Well Name: REGAL LAGER 31-19 FEDERAL COM	Well Location: T21S / R32E / SEC 31 / SESW / 32.4283053 / -103.7145063	County or Parish/State: LEA / NM
Well Number: 21H	Type of Well: OIL WELL	Allottee or Tribe Name:
Lease Number: NMNM109757	Unit or CA Name:	Unit or CA Number:
US Well Number: 3002554423	Operator: OXY USA INCORPORATED

Type of Action: APD Change

Procedure Description: OXY USA Inc., respectfully requests to amend the subject AAPD to revise the BHL, HSU, TVD and Drill Plan. Old BHL: 20' FNL 530' FWL New BHL: 20' FNL 330' FWL Old HSU: 522.32 acres New HSU: 1002.32 acres Old TVD: 10296' New TVD: 10897' *THERE IS NO ADDITIONAL SURFACE DISTURBANCE RELATED TO THIS SUNDRY" Attached is the updated C102, drill plan, directional and APD Change Worksheet.

PECOS DISTRICT DRILLING CONDITIONS OF APPROVAL

C-102 Submit Electronically Via OCD Permitting	State of New Mexico Energy, Minerals, & Natural Resources Department OIL CONSERVATION DIVISION	Revised July 9, 2024 PAGE 1 OF 2
		Submittal Type: ☐ Initial Submittal ☒ Amended Report ☐ As Drilled

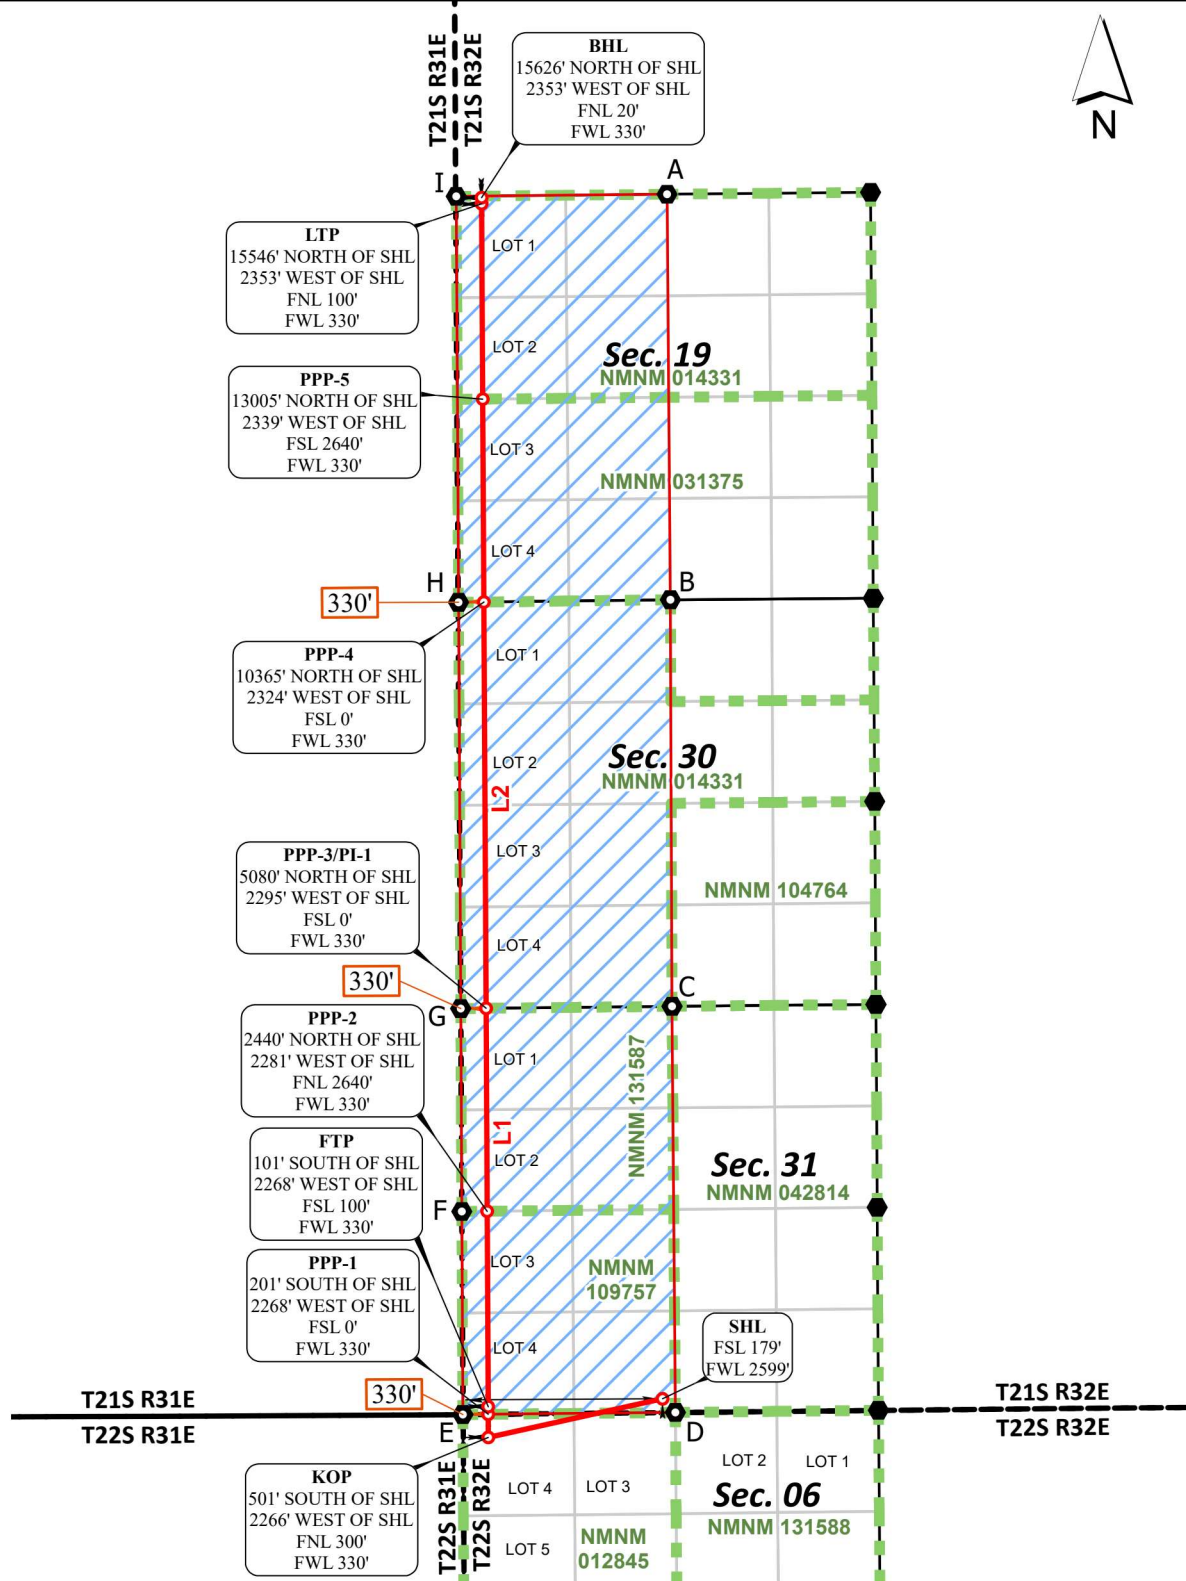
Old BHL: 20' FNL 530' FWL
New BHL: 20' FNL 330' FWL

Old HSU: 522.32 acres
New HSU: 1002.32 acres

Old TVD: 10296'
New TVD: 10897'
